Response to Representations, Agency and Council Comments – DA 26010577

This letter provides a response to the public representations received during notification of variation application DA 26010577. The public notification period concluded on 14 May 2026.

UPDATED SHADOW CAST (WINTER)
 OUTLINE OF ORIGINAL SHADOW CAST
 REV02

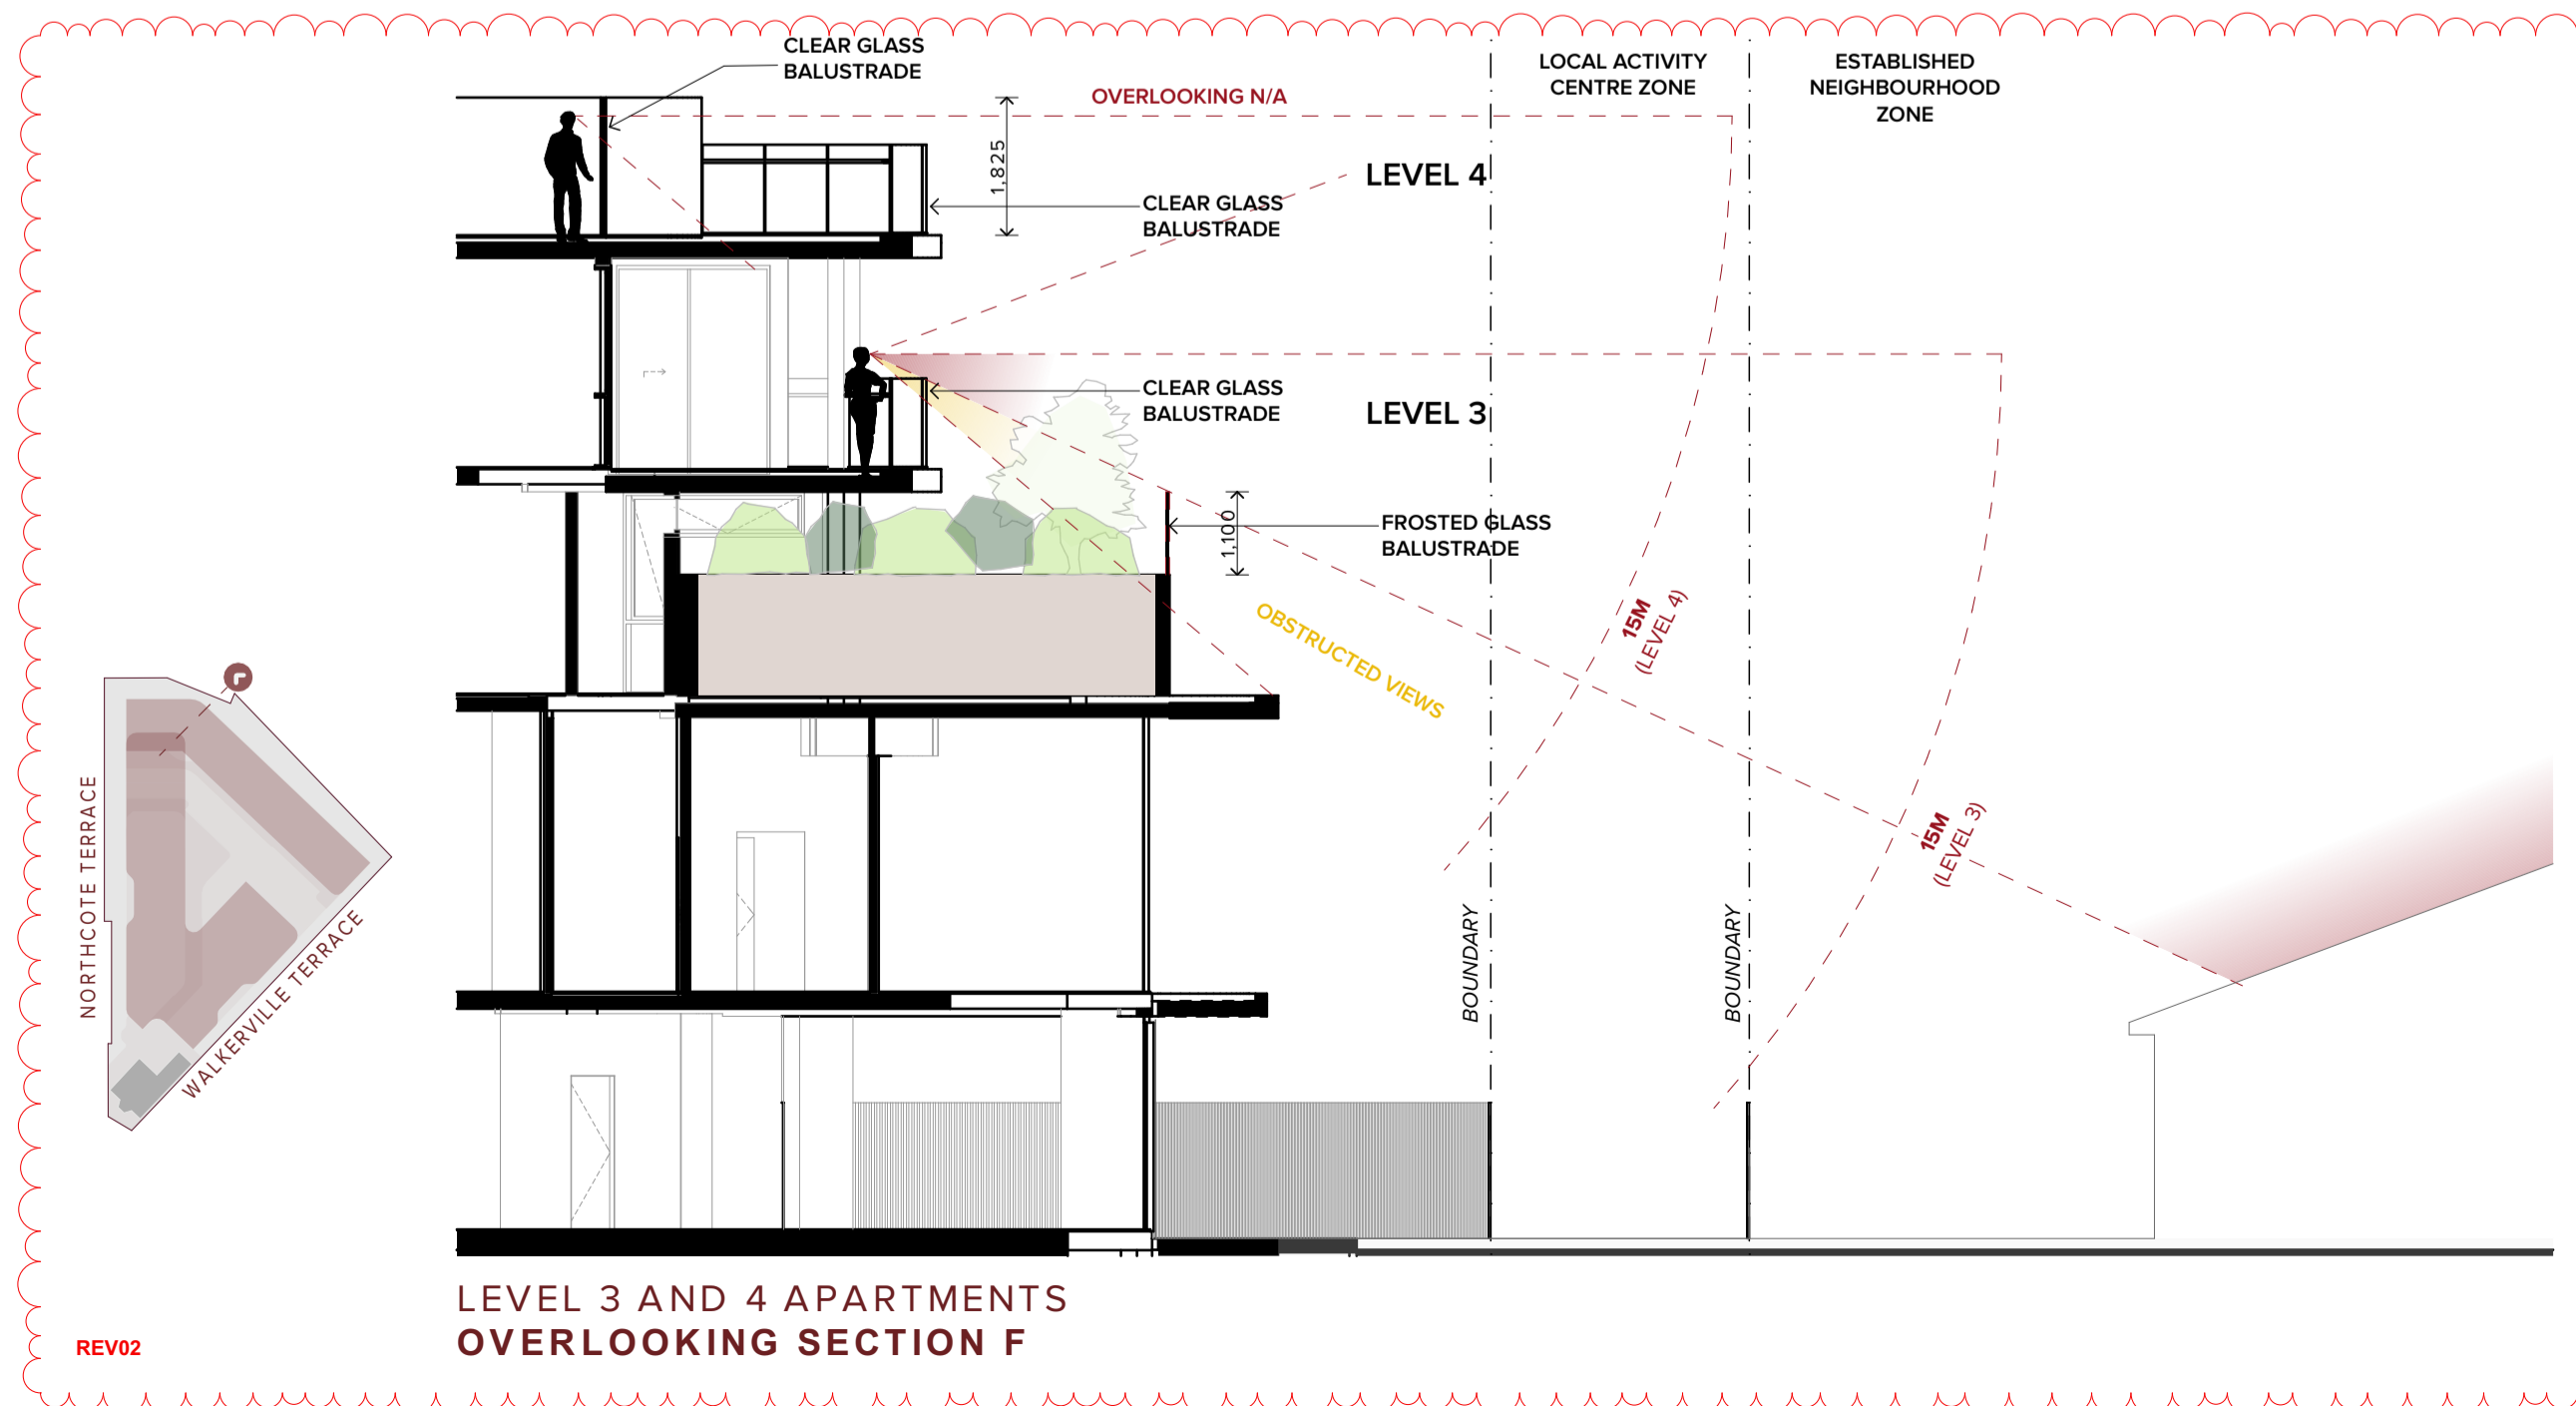
Representors raised concerns with the management of off-site and amenity impacts. This is primarily contained to overshadowing and overlooking.

Shadow analysis prepared by SMFA (see **Annexure A**) shows the additional shadows cast by the variation. This demonstrates that additional shadows are contained to public roads or the adjacent public reserve between the hours of 9am and 1.30pm on 21 June.

At 1.30pm an additional 18m² of shadowing is experienced within the private open space of 6 Walkerville Terrace. Despite this, the private open space receives at least 5 hours of unencumbered sunlight to satisfy DPF 3.2 above.

By 3pm there is no additional shadowing to private open space within 60m of the development (definition of adjacent land).

GROUND FLOOR APARTMENTS OVERLOOKING SECTION E

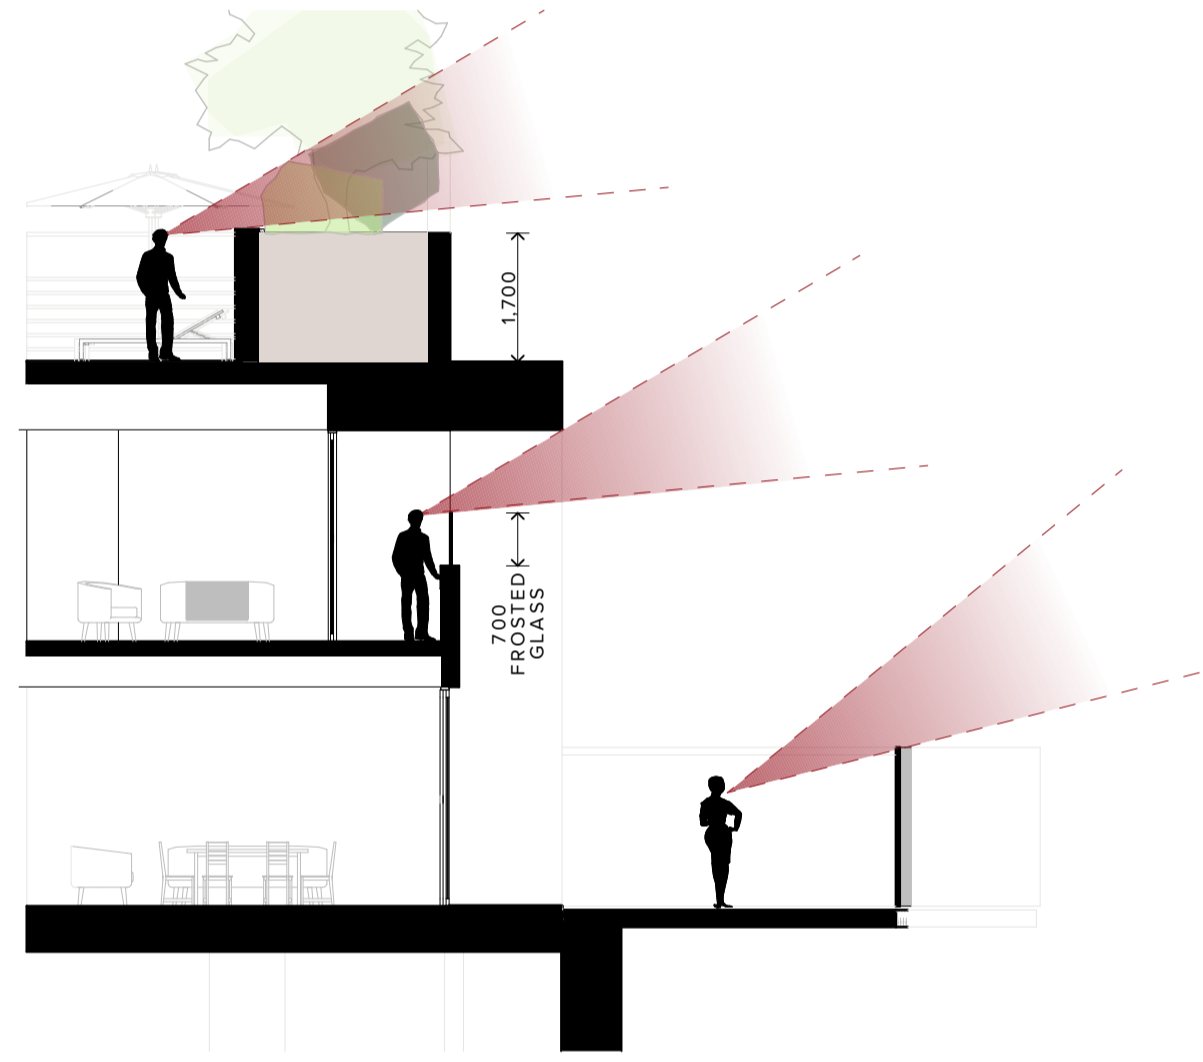
“The applicant shall provide an updated plan nominating privacy screening treatments between apartments which face each other, to restrict views from apartments 308 and 406 to the north-east and the balcony of terraced apartment 008.”

- 29m² of the Established Neighbourhood Zone is within 15m of the apartment 307 balcony. 1.5m high opaque balustrades have been applied to the portion of the balcony within 15m. As demonstrated in Section F, this screening sufficiently mitigates overlooking of the adjacent private open space areas of Unit 5, 6 and 7 17 Walkerville Terrace.
- Terrace apartment 008 has been removed by the variation. Remaining terrace dwellings continue to provide sufficient screening measures to mitigate overlooking as shown in Section E and D.

WEST STREET ELEVATION (NORTHCOTE TERRACE)

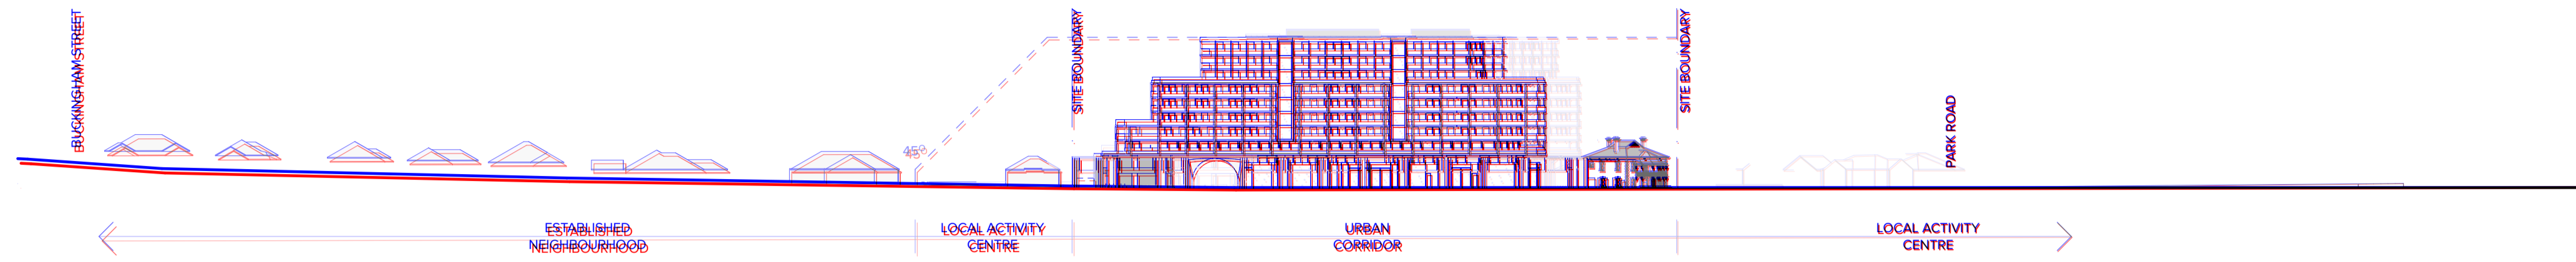
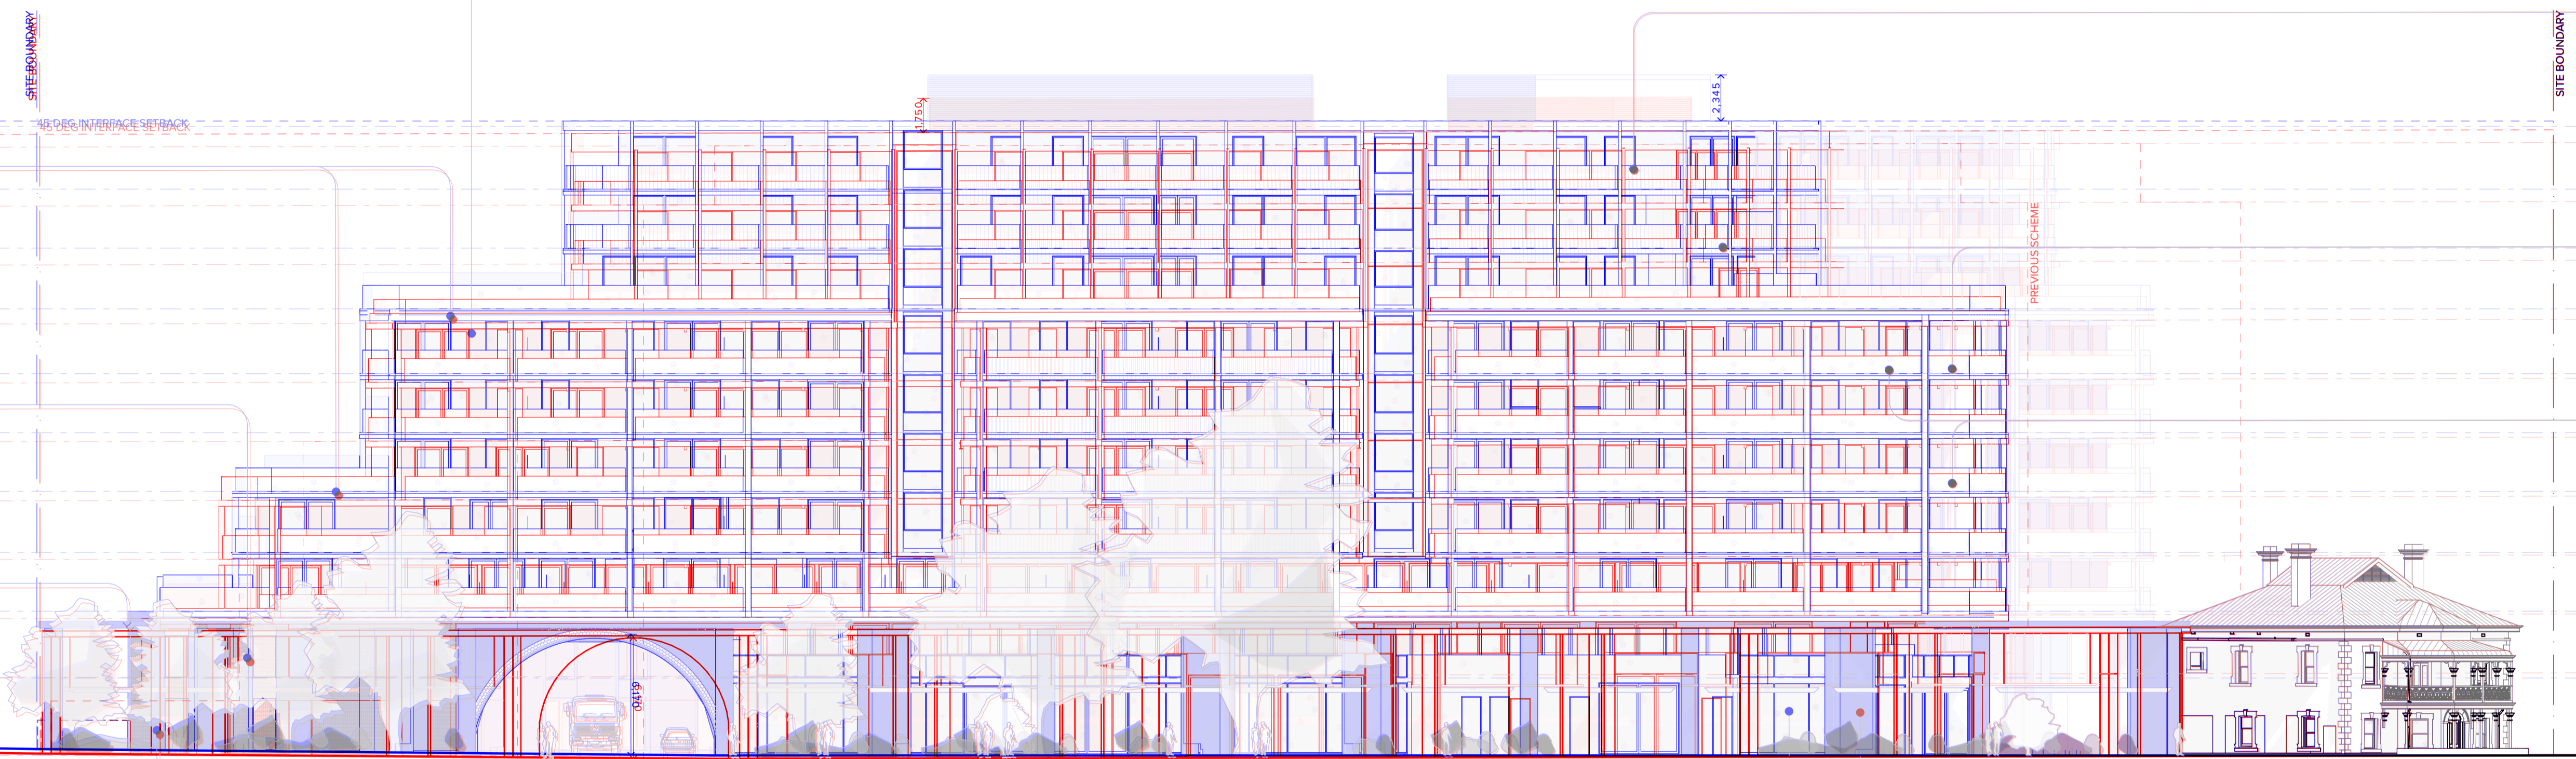
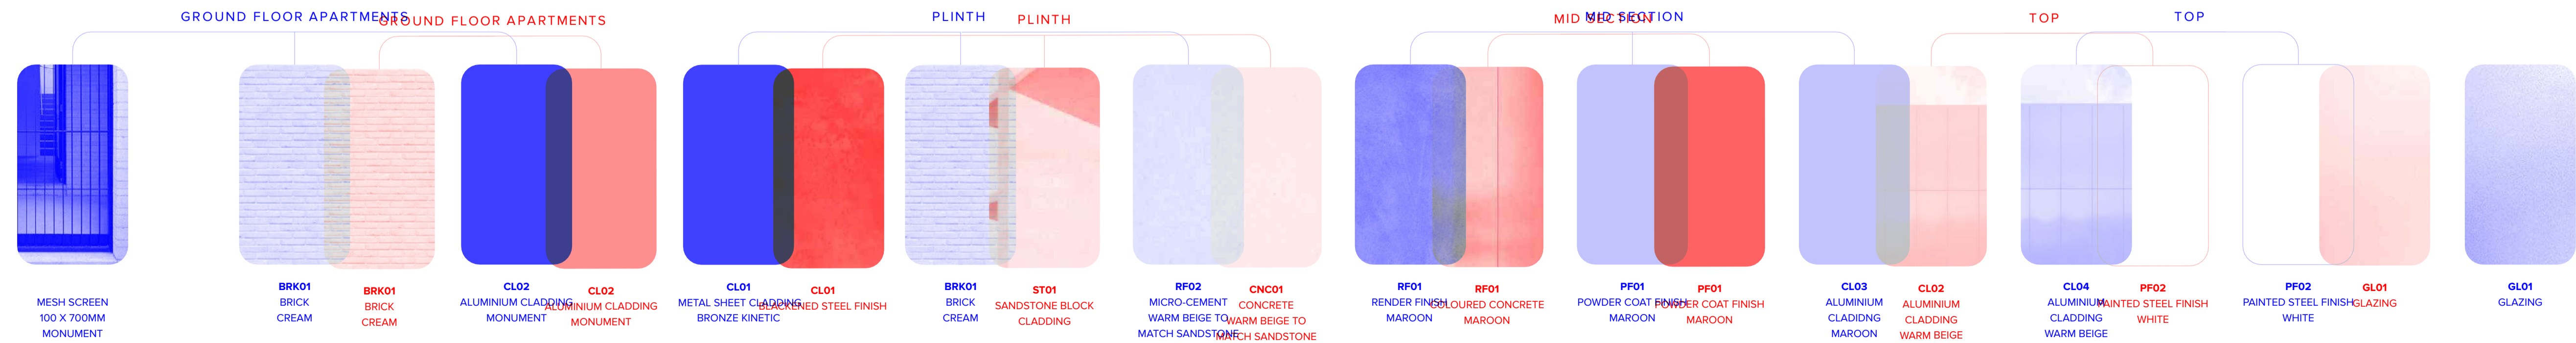
The representators raised concerns with the proposed height increase to the 10-level building.

We have also prepared a height comparison overlay for the western elevation, see **Annexure C**. This shows a comparison between the stamped plans for DA 24029287 (shown in red) and the proposed variation (shown in blue).
